Subject: Utility Trench Survey at Chevron Service Station #9-0504, 15900 Hesperian Boulevard, San Lorenzo, California.

UNDERGROUND UTILITY LOCATION MAP
 Chevron Service Station No. 9-0504
 15900 Hesperian Boulevard
 San Lorenzo, California

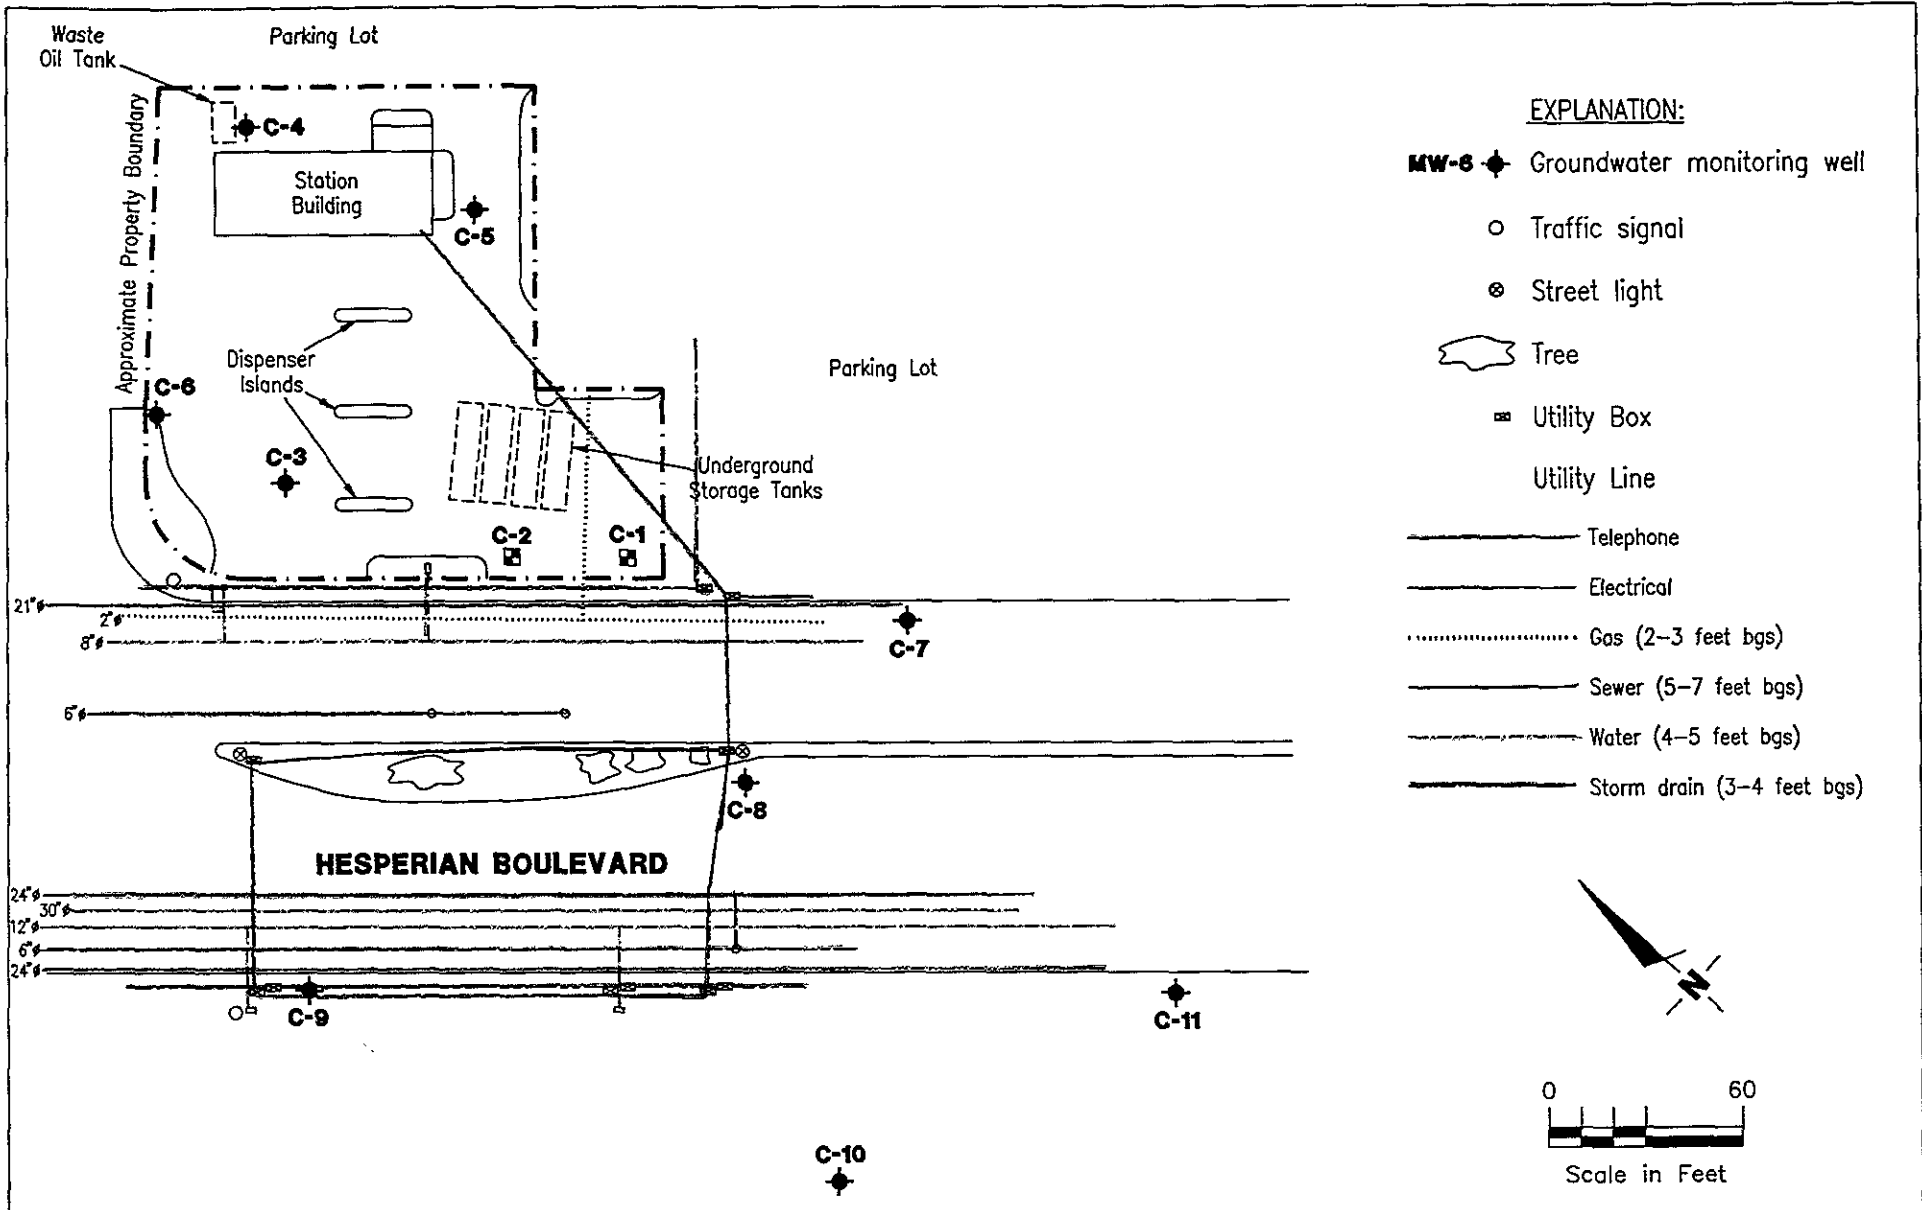
3/21/97
Due to the fact that
DTW is below 7 - to 8-foot
bgs at least 90% of the
time, it appears that
utility lines are not acting
as conduits of concern.
-Julius Stein
